Monday, 3/17/2008 12:00:05 PM Kim Johnston User: **Process Sheet** : CU-DAR001 Dart Helicopters Services **Drawing Name** : VALVE ASSEMBLY (1/4") Customer Job Number : 38056 : 10962 **Estimate Number** : D20014 **Part Number** P.O. Number D2001 REV C : 3/17/2008 S.O. No. : **Drawing Number** This Issue : NC : N/A Project Number Prsht Rev. : 11 : PURCHASED PARTS : C First Issue Type **Drawing Revision** : 34235 Previous Run Material **Due Date** : 3/24/2008 Qty: 12 Um: Each Written By Checked & Approved By Comment : Est. 04.07.06 New Issue KJ/RF Additional Product Job Number: Machine Or Operation: Description: Seq. #: PURCHASING 1.0 Comment: PURCHASING C208103117 5933 Issue P/O: P/N: 76-101-32 (1/4 NPT) Possible Supplier: Flo-Control Inc. Material release note is required 2.0 7610132 VALVE Comment: Qty.: 1.0000 Each(s)/Unit Total: 12.0000 Each(s) **VALVE** 3.0 PACKAGING : PACKAGING RESOURCE #1 Comment: PACKAGING RESOURCE #1 Recieive & Inspect for Transit Damage Ensure Material Release Note is attached 4.0 QC6 Comment: DIMENSIONAL CHECK 5.0 SMALL FAB SMALL & MEDIUM FAB RESOURCE 1 Comment: SMALL & MEDIUM FAB RESOURCE 1 Remove existing ID numbers and replace with Dart P/N & B/N 1508.03

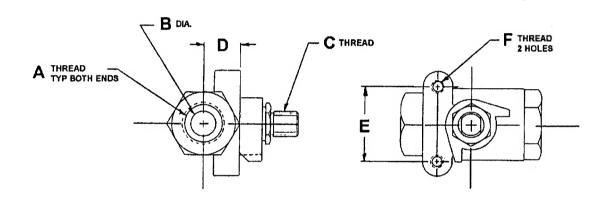
David and I found no problem with this modification manufacture need to do, but we suggest this modification need to reflect in the drawing as an option since this is inconsistent problem.

QC reported that the orientation of the left hexagonal fitting press fitted into the valve housing is inconsistent. Results, when trying to assemble the valve on the heater, there is some interference. They are asking if the parts would be acceptable if machined down as indicated per the provided sketches.
